Introduction: Project Background

- Location 515 Westlake Avenue N.
500 9th Avenue N.
- SLU Street and Open Space Context The block is bounded by Westlake Avenue N., Mercer Street, 9th Avenue N. and Republican Street and is located one block south of Lake Union.

EDG 6 June 2012

Summary of Priorities & Board Recommendations

5. North façade on Mercer St.:

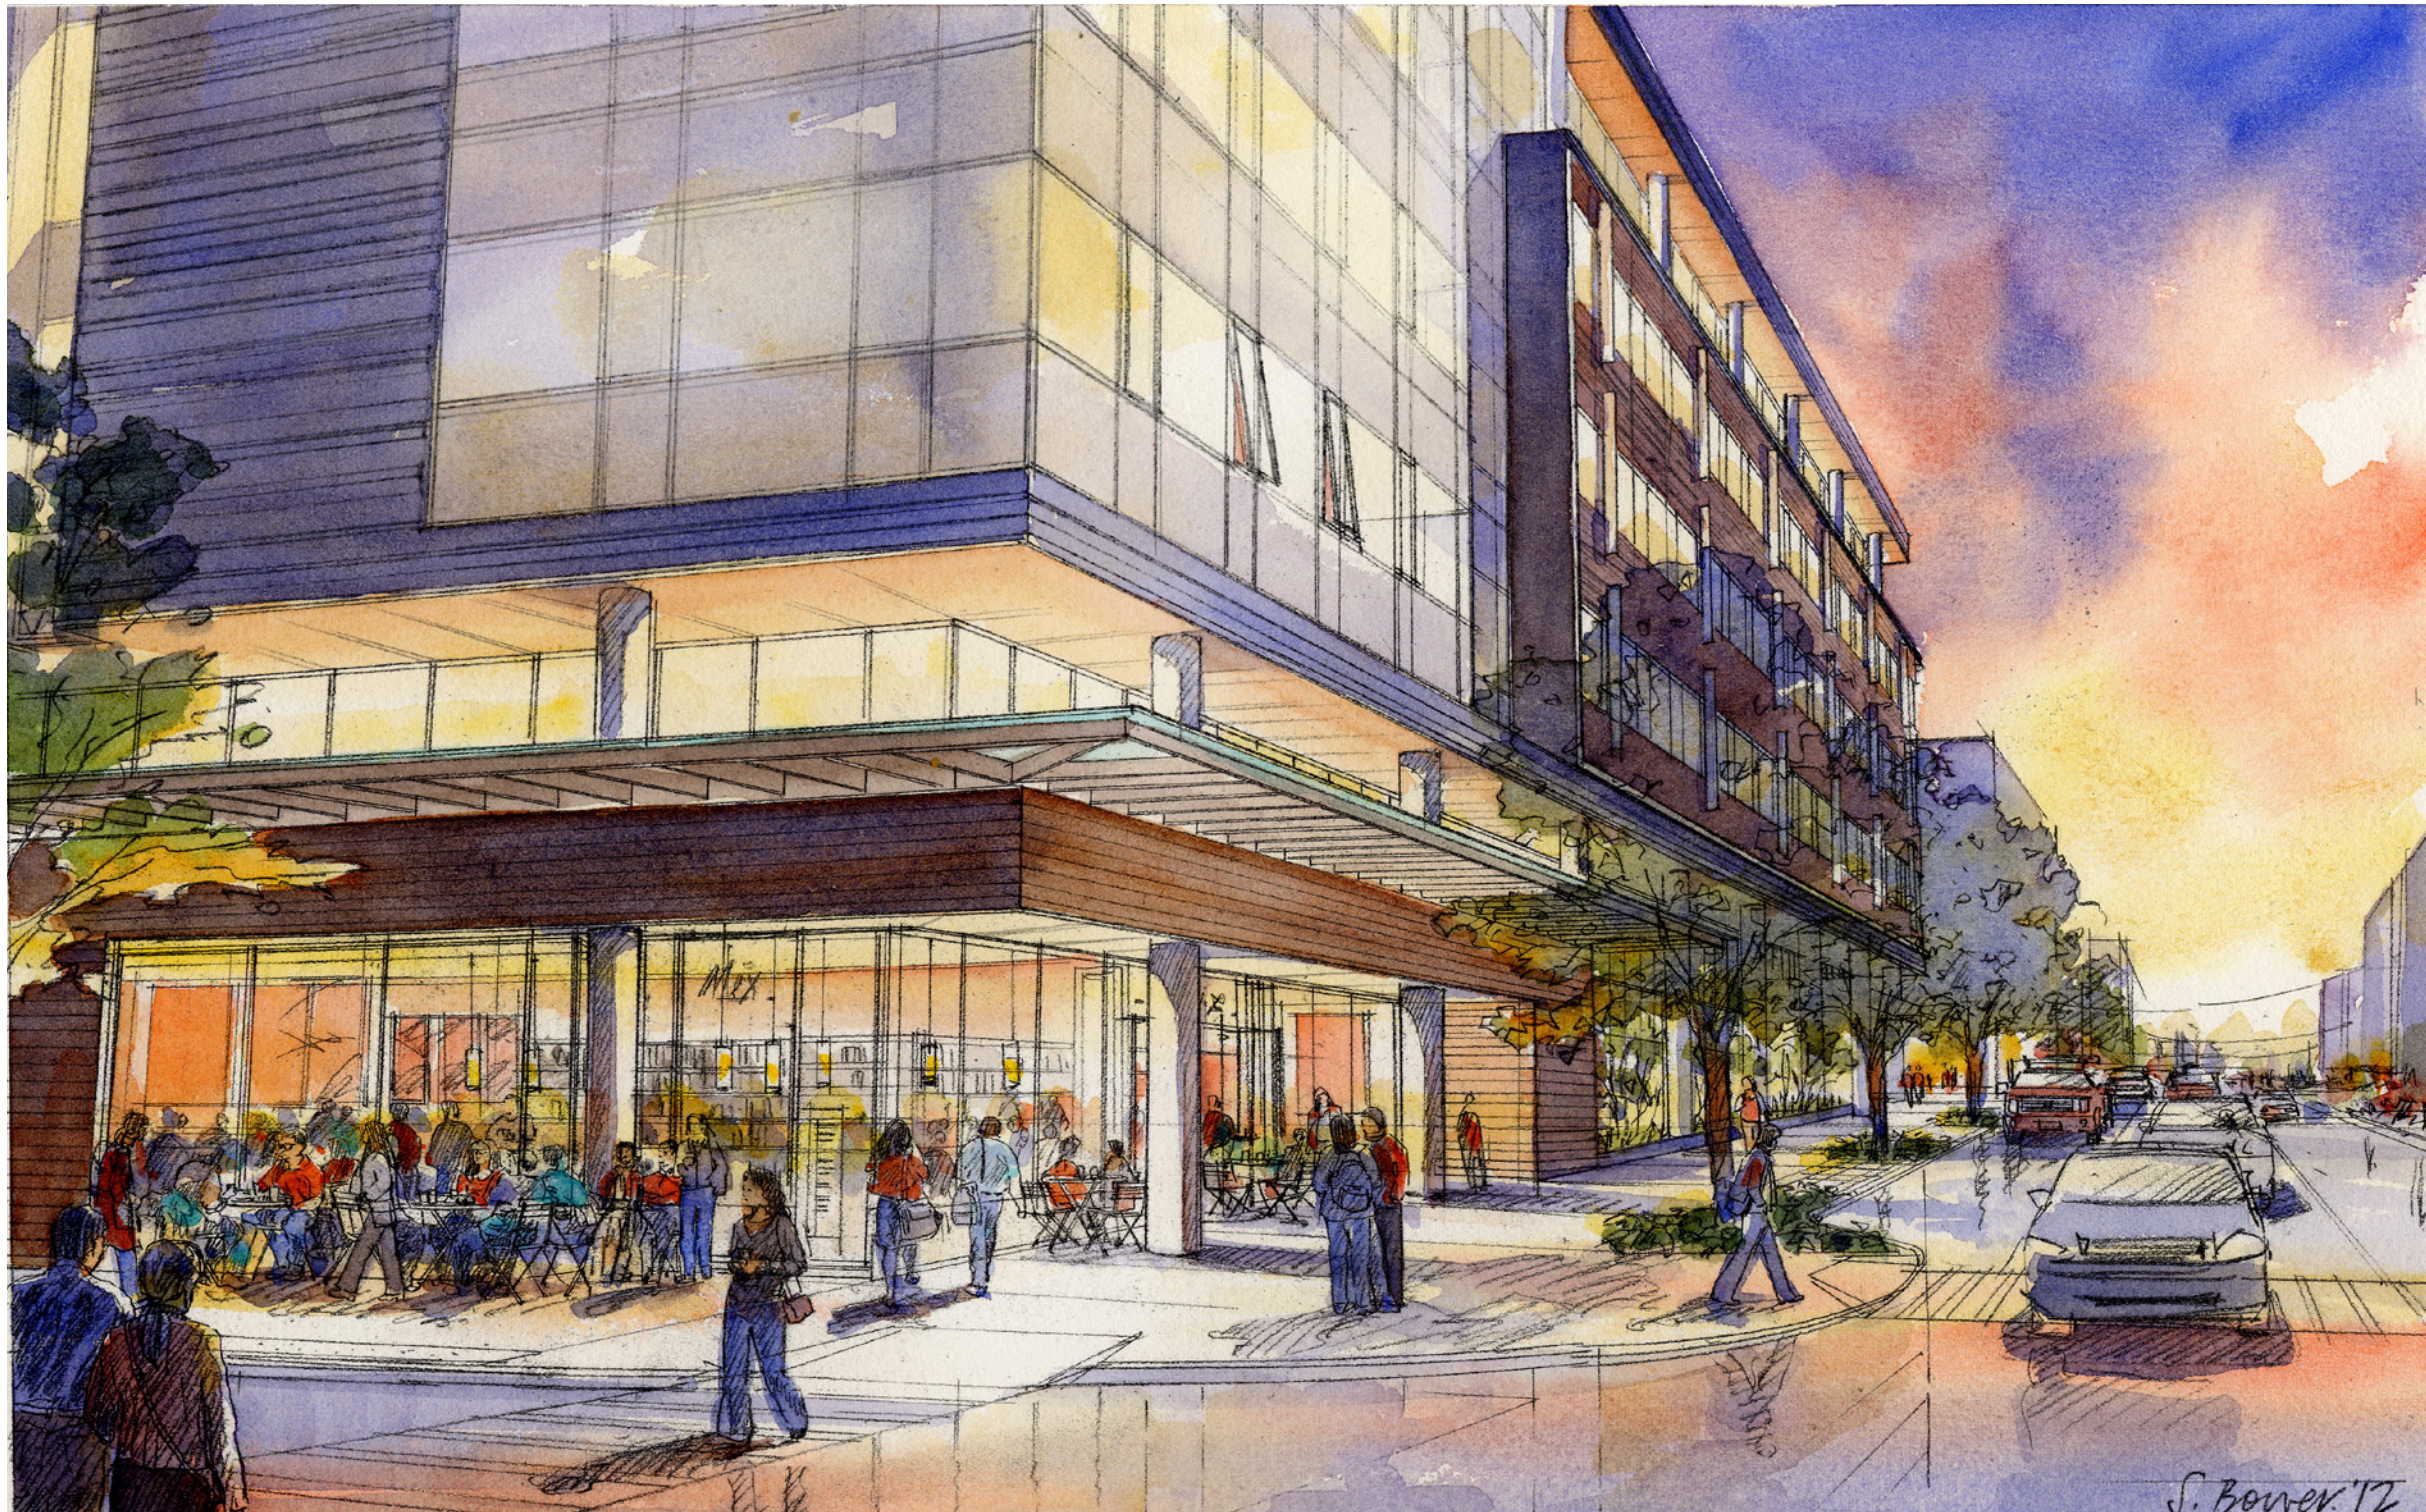
- The Board noted this façade appears potentially problematic, due to the retail entries fronting on the pedestrian connection and the building turning its back on Mercer St. (A-3, D-1)
- The Mercer St façade should include a visible major pedestrian entry. (A-3, D-1)
- The use at that façade of meeting rooms is also potentially problematic, since these spaces are often unoccupied. The applicant should demonstrate how the street level facades will encourage an activated street frontage on Mercer St. (A-4)
- The design of this façade needs to include significant design moves to break down the appearance of the long façade and to create human scale. (B-1, A-4, C-3)

Mercer Street is a major urban connector with a large-scale high traffic function (60,000 cars per day). To enhance pedestrian vitality, the project has added retail at the northeast and northwest corners and provided points of access at both retail spots. Due to the slope of the site, and the desire for building lobby entry on Westlake, the mid-block zone is set back to create a landscape design opportunity, providing scale and varied texture, in a block that is without the Mercer boulevard median landscaping.
